March 31, 1982
AW-82-21

APPLICATION FOR WITHHOLDING PROPRIETARY
INFORMATION FROM PUBLIC DISCLOSURE

SUBJECT: Response to Questions on WCAP-9561, "Bart-A1: A Computer Code for the Best Estimate Analysis of Reflood Transients" (Proprietary)

SECTION 2.0

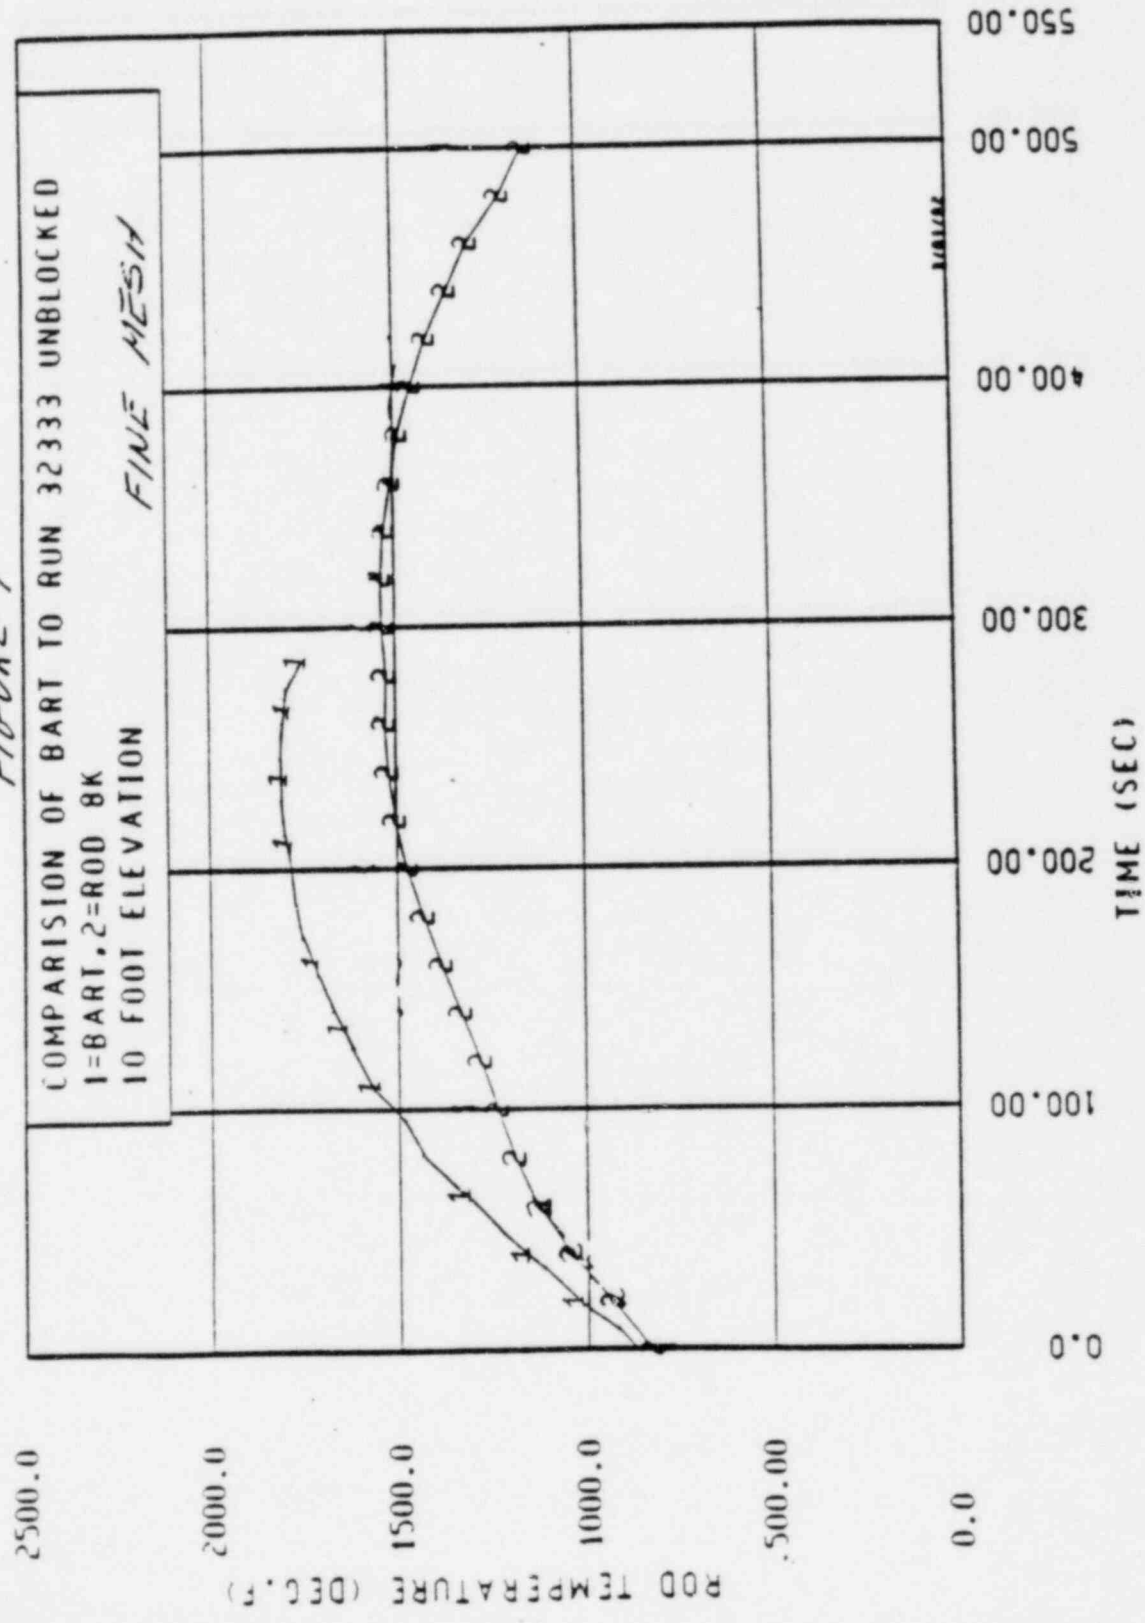
1.) How sensitive are the BART results to axial mesh size?

To investigate BART sensitivity to mesh size, the BART calculation for run 32333 (see response to Question-4, Section 6.0) was repeated with the axial mesh size reduced by a factor of two.

Figure 1 - 3 show that there is an overall increase in calculated temperature of about 100°F. Figures 4 to 7 show that the prediction still compares well with data.

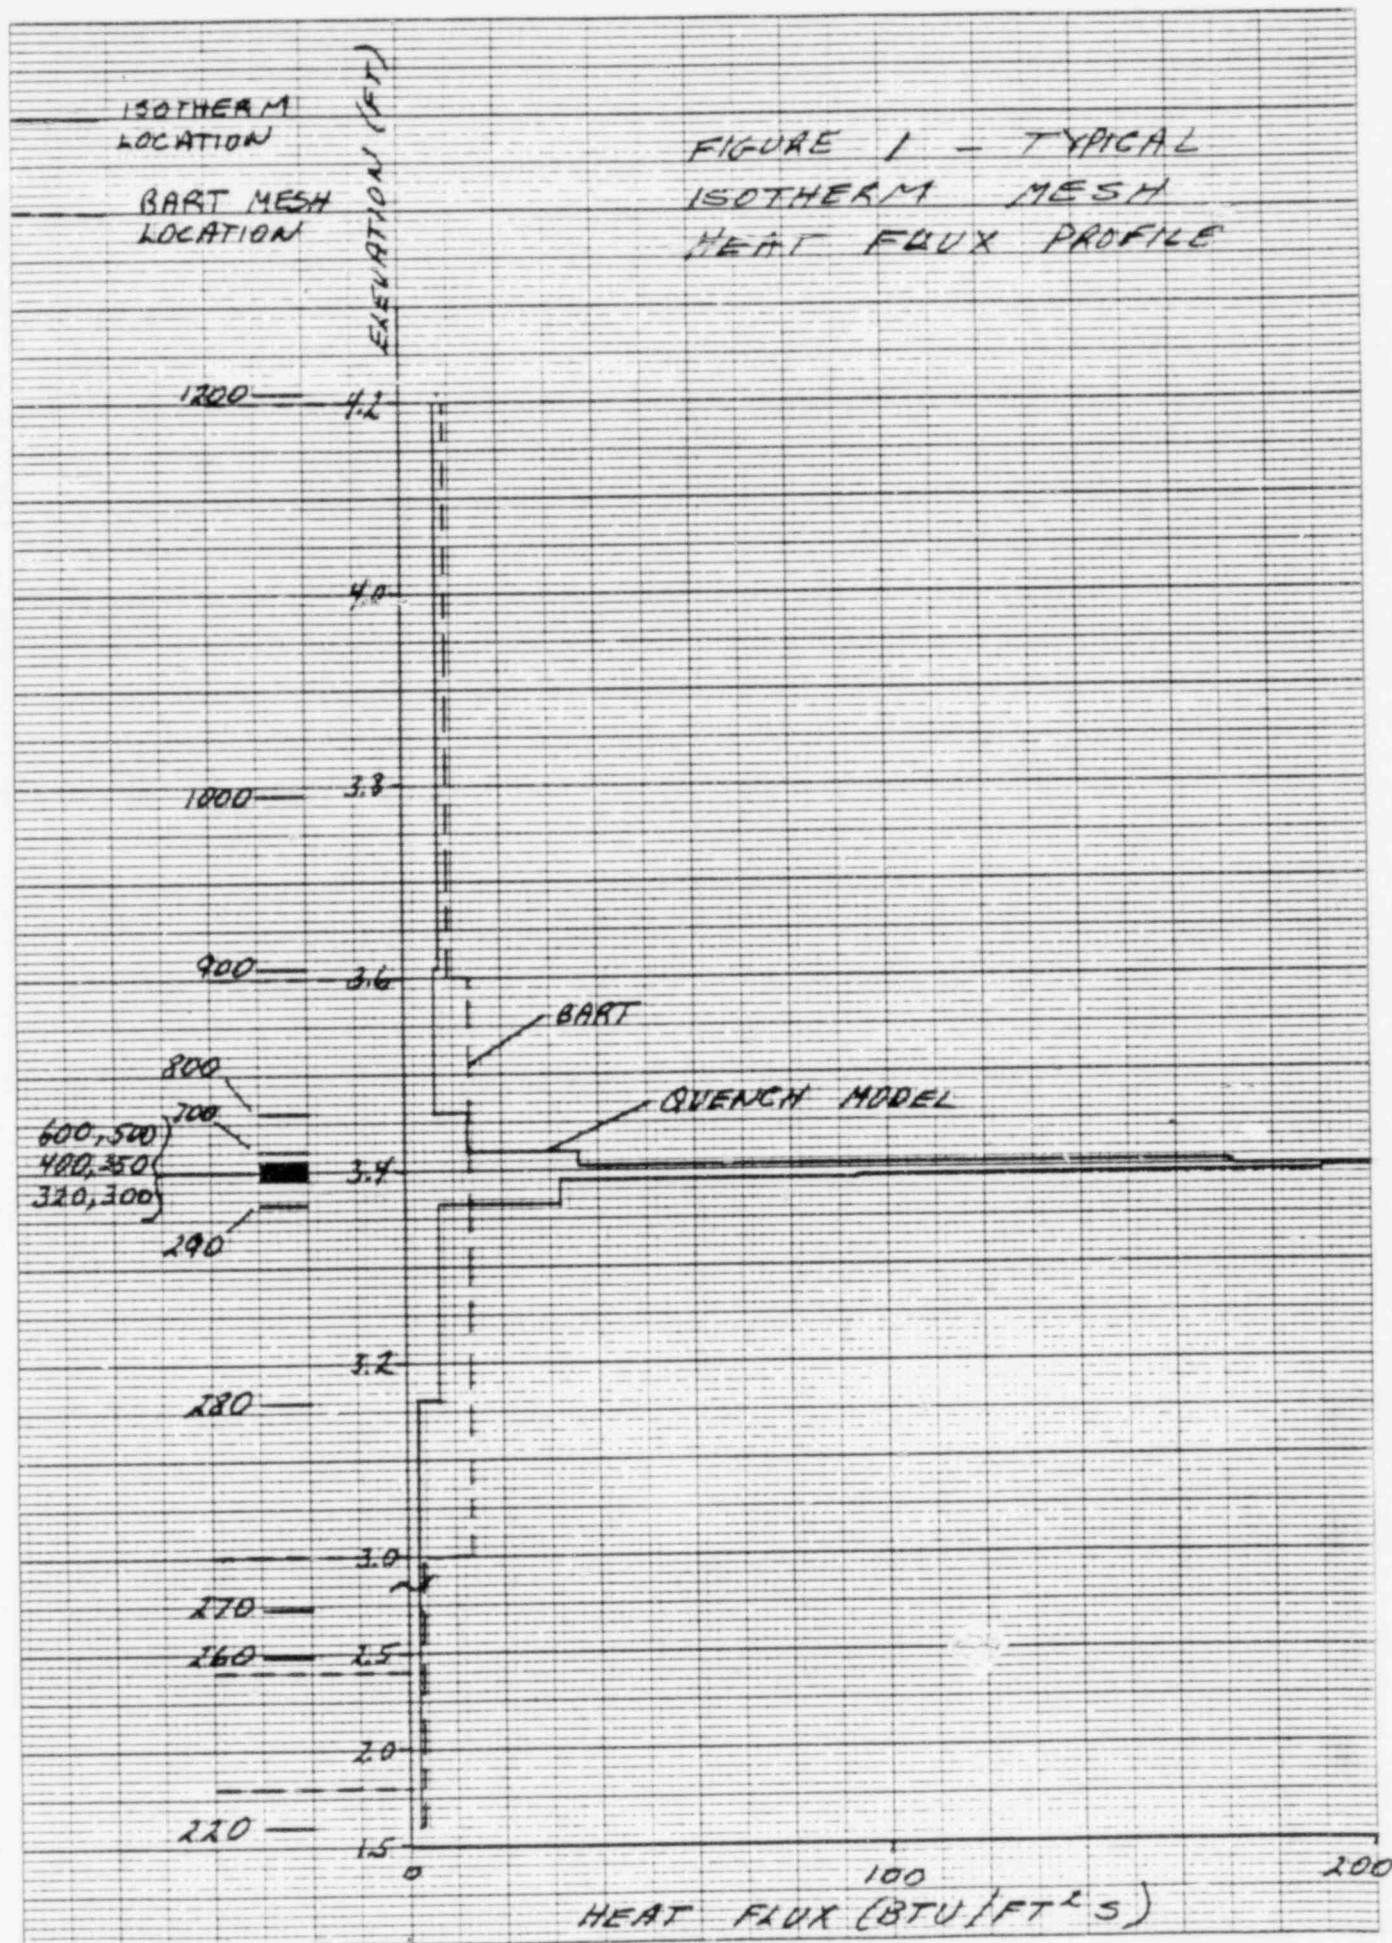
- 5) Due to the general upward propagation of energy released during reflood, doesn't the linearized apportioning of energy favor the quench front advance; e.g., at $Z_q = Z_i$, all the heat is realized into the lower node reducing the subcooling there rather than generating more steam at the quench plane and thereby slowing the advance of the quench plant.

Sufficient detail exists in the isotherm mesh to avoid, the severe distortion suggested above, as can be seen from the attached figure.

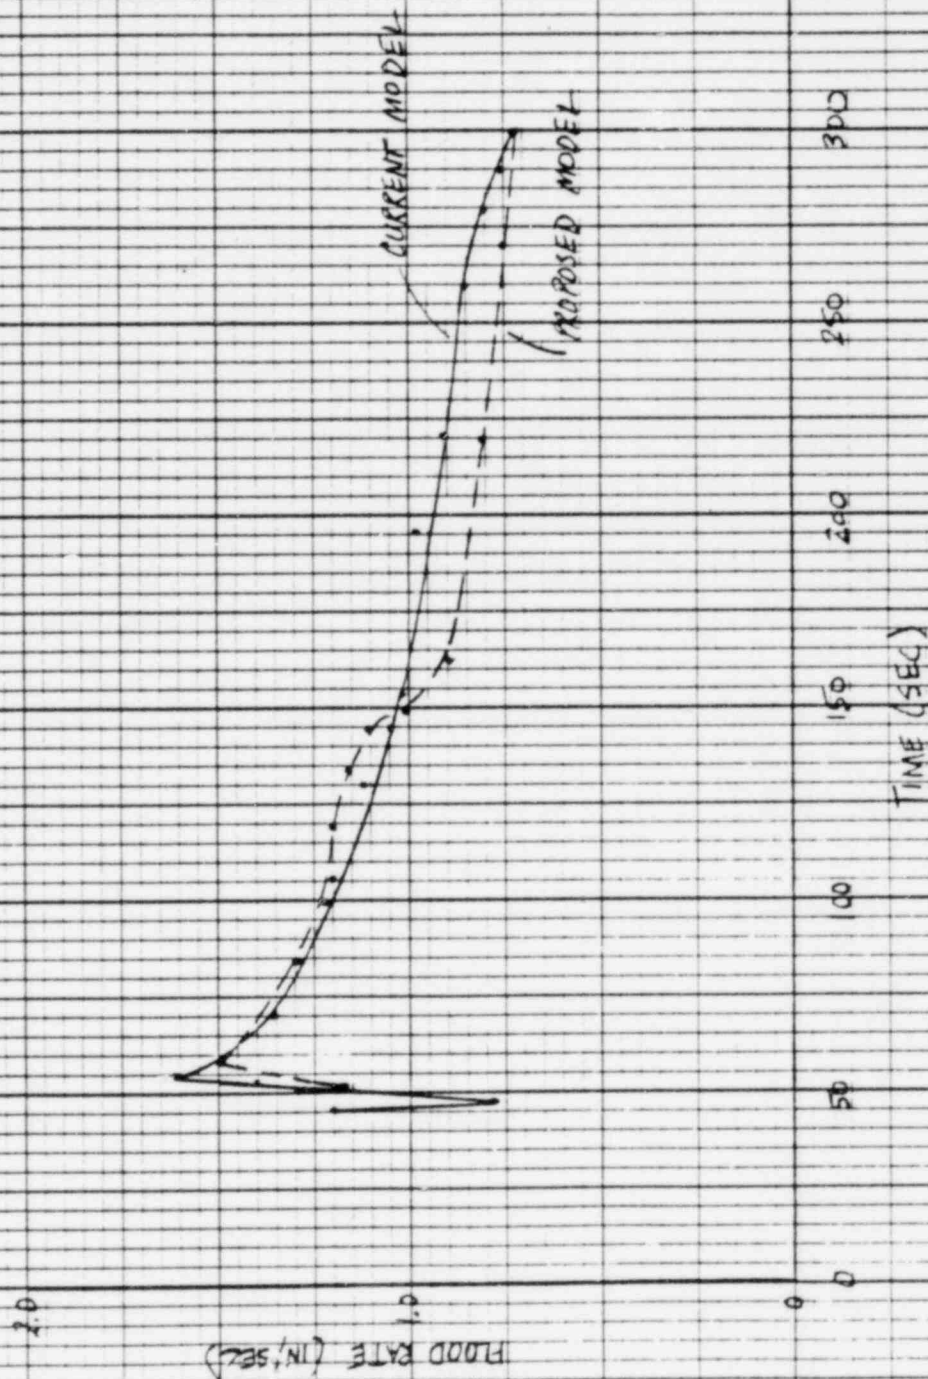
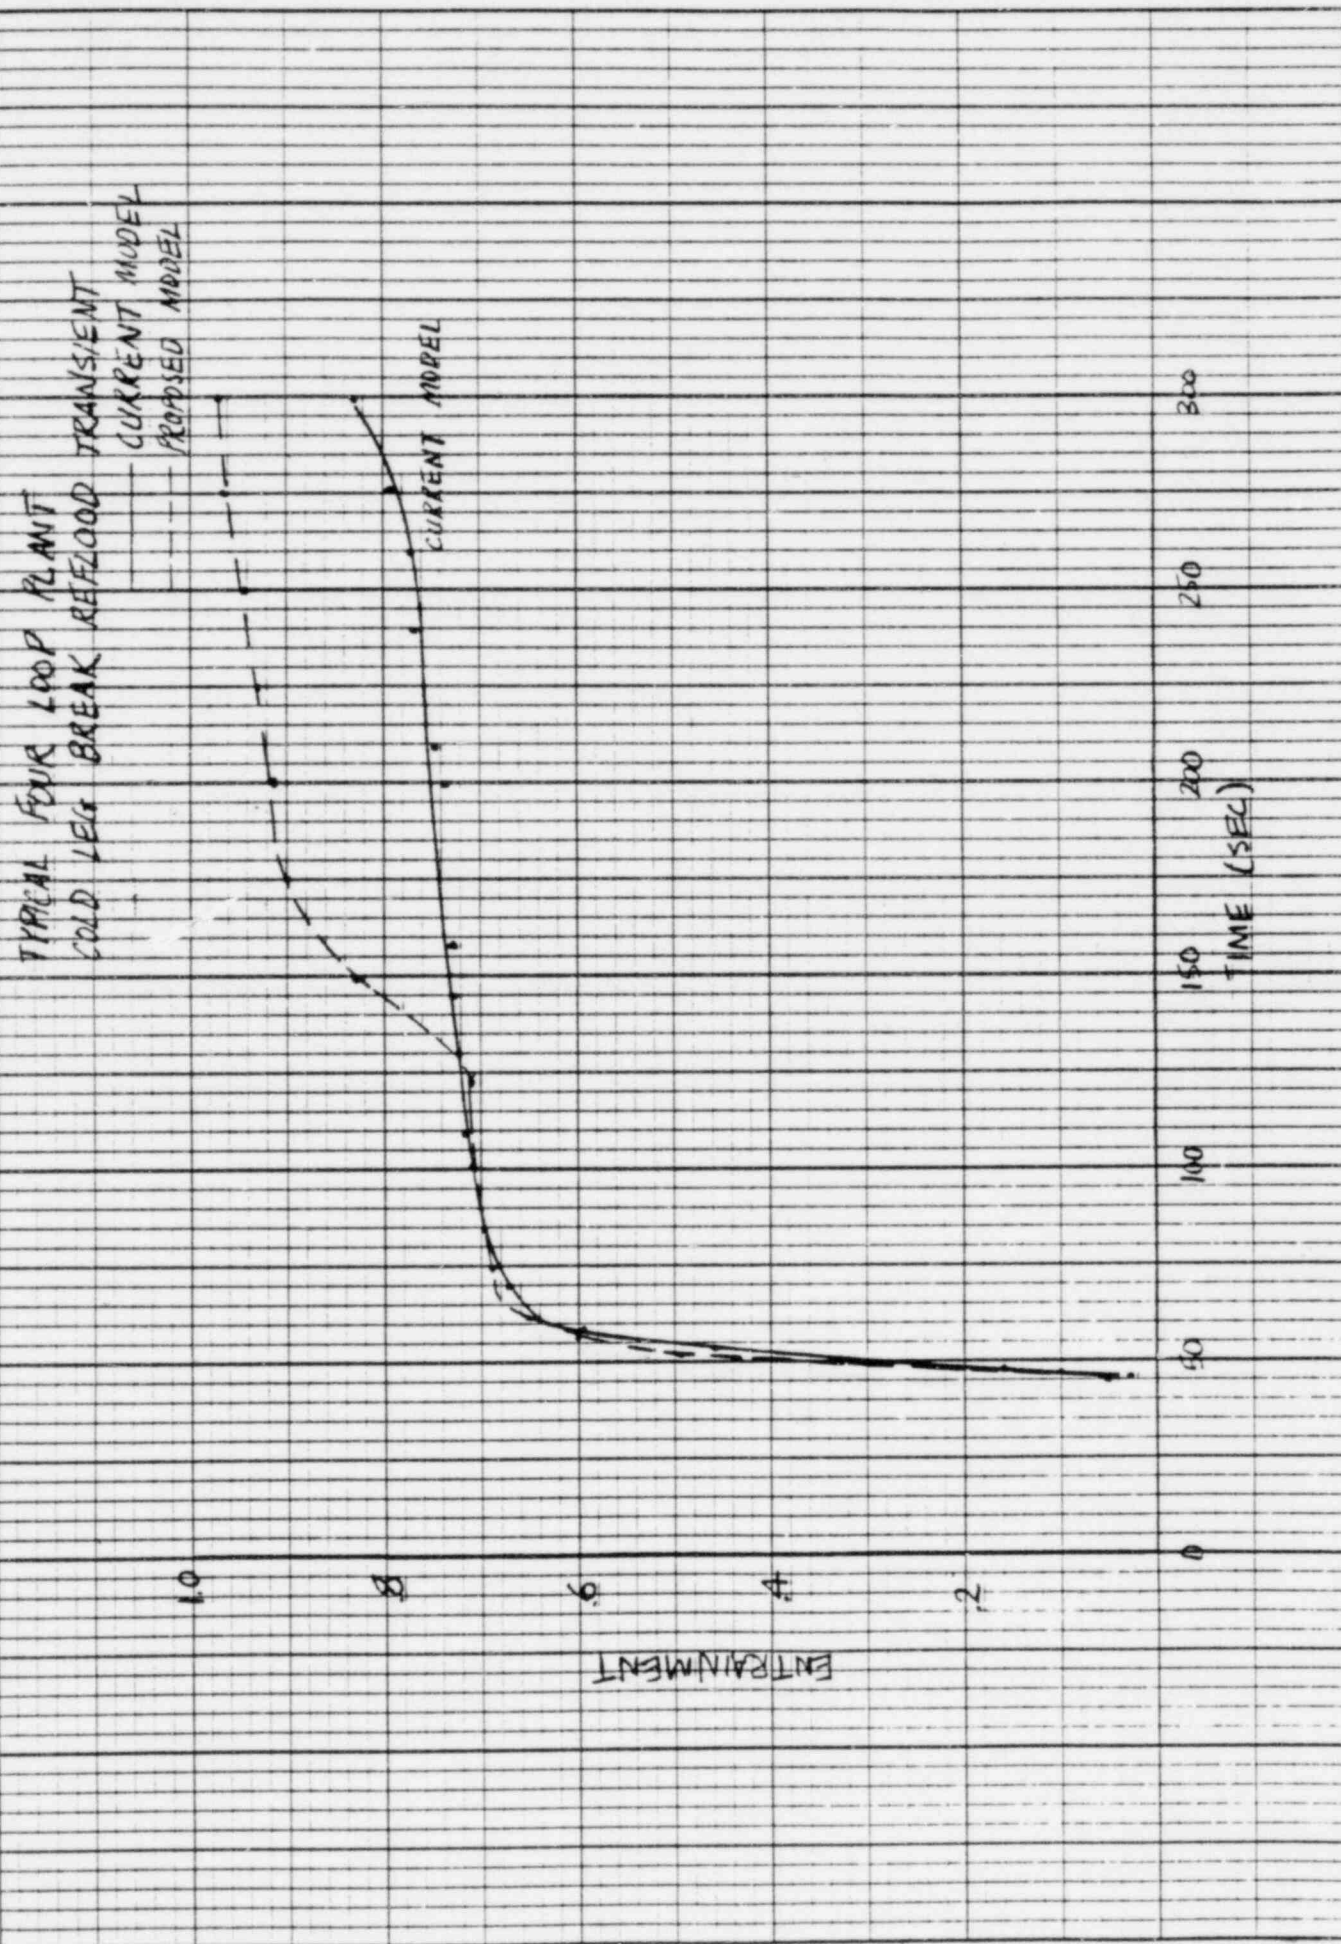
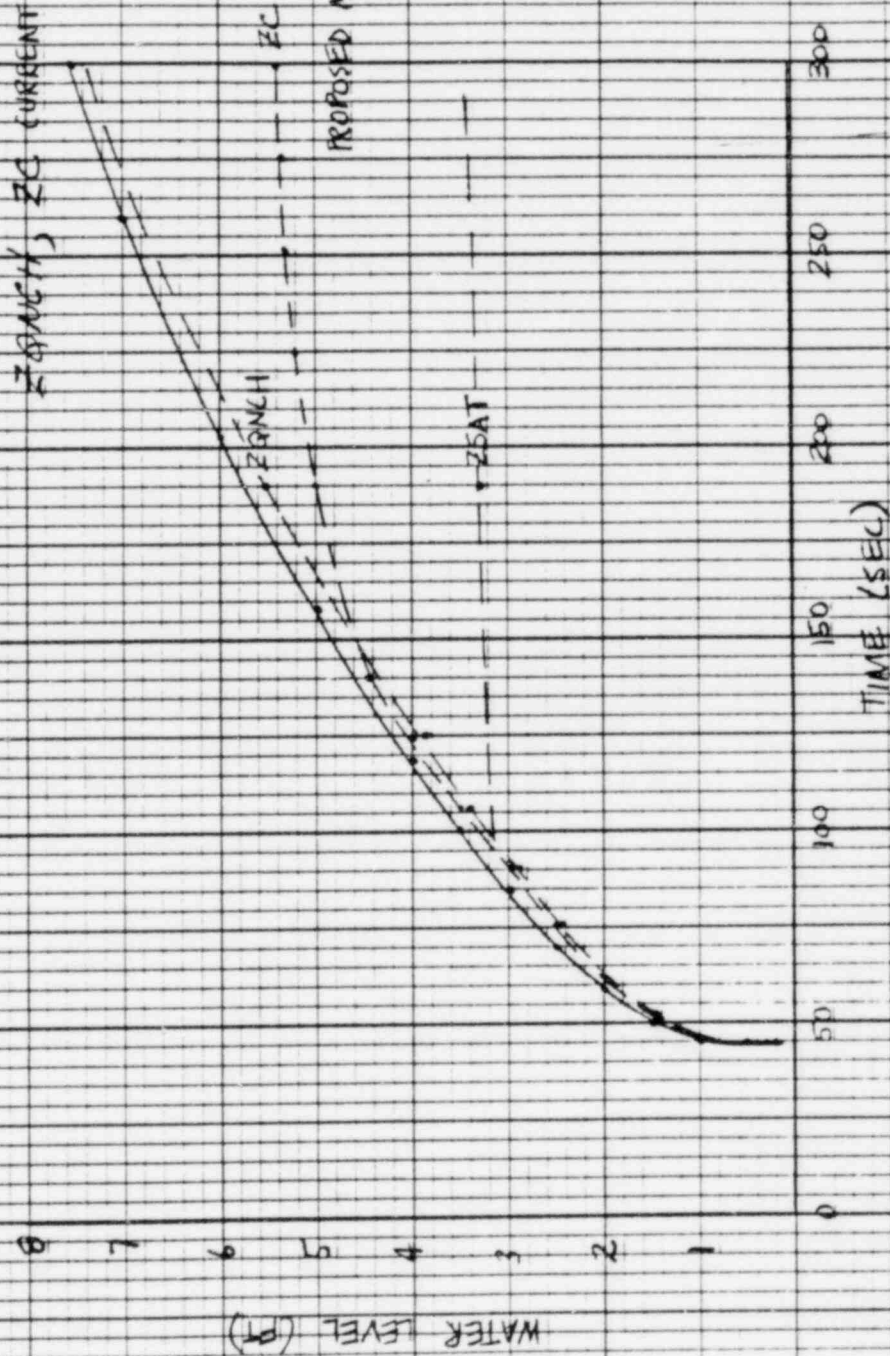
- 2.) A comparison of the current and proposed WREFLOOD calculation is not presented. This is needed. In particular a comparison of the entrainment rate.

Figures 1 to 3 compare the flooding rate, liquid and quench levels, and entrainment fraction for a typical four loop plant.

Entrainment is seen to begin slightly earlier in the proposed calculation. This is due to the term:

which has been included in the entrainment correlation. In the current model the earlier entrainment is accounted for by subtracting Z_{st} from the quench front location in the LOCTA calculation [1]. As reflood progresses, boiling commences below the quench front. Subsequently, entrainment is controlled primarily by the movement of this line. The increased entrainment reduces the flooding rate in the proposed model, but this difference tends to disappear because the downcomer driving head remains high due to the lower density in the core.
